Pierce Township Board of Trustees Meeting & Public Hearing
950 Locust Corner Road
Thursday, December 8, 2022
6:00pm

**Pierce Township
Board of Trustees
December 8, 2022
Case Number: ZC2022-004**

Ninemile-Davis Road PUD

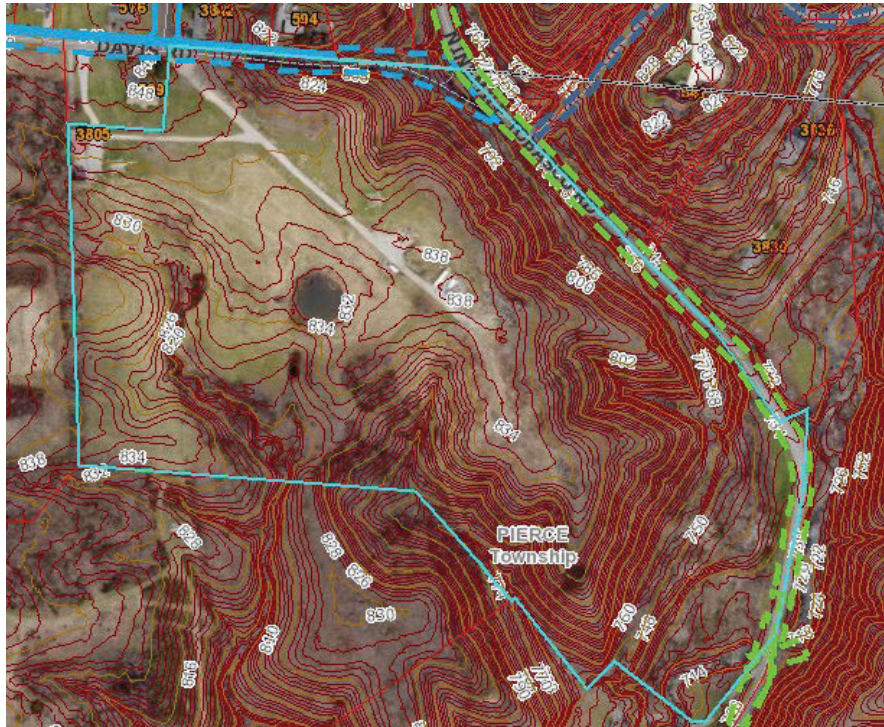
- The lot sizes and open space are not varied nor designed in an effort to accommodate resource protection and avoidance of hillsides. Significant grading is shown in the hillsides. The design is conventional and fails to cluster lots, resulting in grading and incursions into the trees and hillsides, as well as the elimination of the pond in the center of the site. At least 9 lots encroach on the tree line and hillside.

- Land disturbance must be minimized (and should be delineated) for a site with a profile of steep hillsides. It is advisable to limit the land disturbance to the contours of the plateau (avoiding the steep declines – follow the tree line and remain on the open plain). (Steep slopes 20-30%+ are typical and can be seen densely contoured in red, per the aerial, below). Cluster development is an alternative option to the PUD or other conventional approaches.

- There is a 0.18 acre Freshwater Pond habitat on site classified as a PUBGh proposed to be entirely disturbed and removed. This similarly conflict with Objective 10 as well.
- At least 9 lots encroach on the tree line and hillside.
- Based on downstream impacts, both impervious surface should be limited and on site collection capacity should be above the minimum standard, unless increased conservation steps are taken. The site sits on a plateau and has proposed conventional stormwater techniques, with no regard for creative approaches.
